### CLARIFICATION Nº5

### RFP No: 009/ REIUP/UGPE

**Project: Renewable Energy and Improved Utility Performance Project (REIUPP)**

**Contract title: ISD No: 009/REIUP/UGPE - Engineering Procurement, and Construction for**

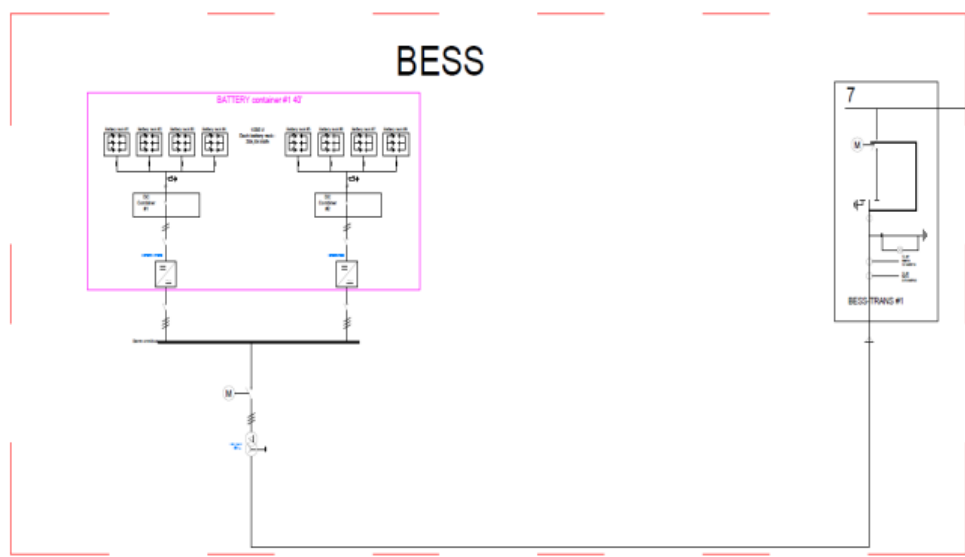
**QUESTION 34:** *for MAIO, please confirm that all equipment related to BESS inside the red highlights are out of our scope of supply.*

**Answer 34:** Design, procurement, and Installation of BESS and its equipment is OUT of scope (for the 4 sites). Please refer to the RFP – Employers requirements and the minute of the pre-proposal meeting.

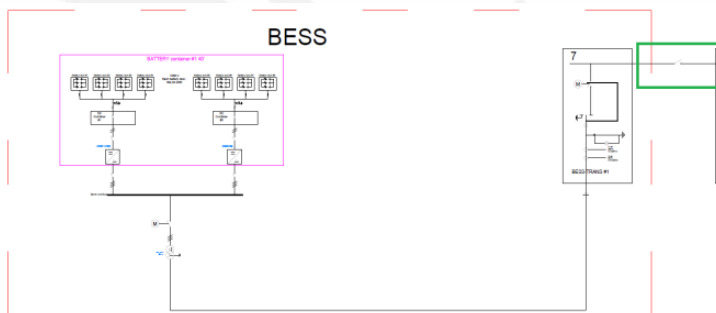
**Question 35:** *for MAIO, Please confirm that the connection to MV switchgear highlighted in green is out of scope.*

**Answer 35:** Please refer to the updated SLD provider with the clarification 4. The BESS is now connected to the Electro Power Plant. The MV Switchgear doesn't exist then.

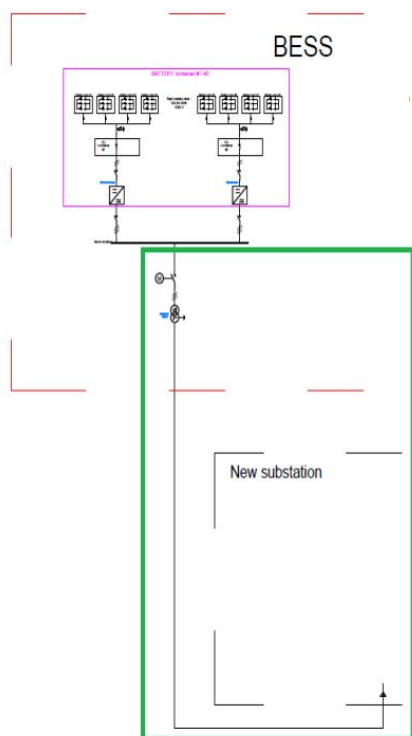
**QUESTION 36:** For Santo Antao, please confirm that the connection highlighted in green between BESS and MV switchgear is out of scope.

**Answer 36:** Design, procurement, and Installation of BESS and its equipment is OUT of scope (for the 4 sites). Please refer to the RFP – Employers requirements.

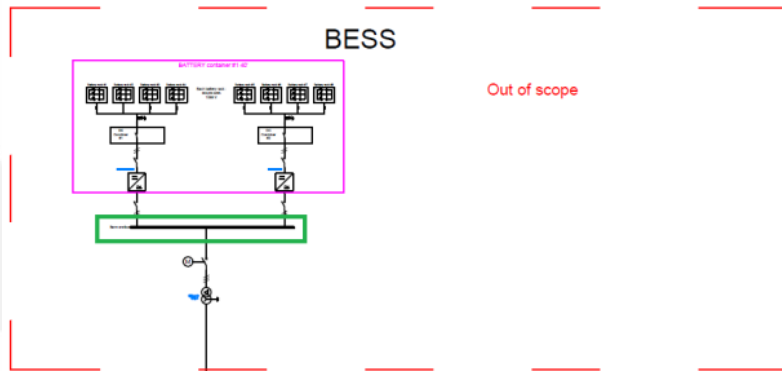
**QUESTION 37:** *Please confirm that the highlighted in green in BESS is out of our scope.*

**Answer 37:** Design, procurement, and Installation of BESS and its equipment is OUT of scope (for the 4 sites). Please refer to the RFP – Employers requirements.
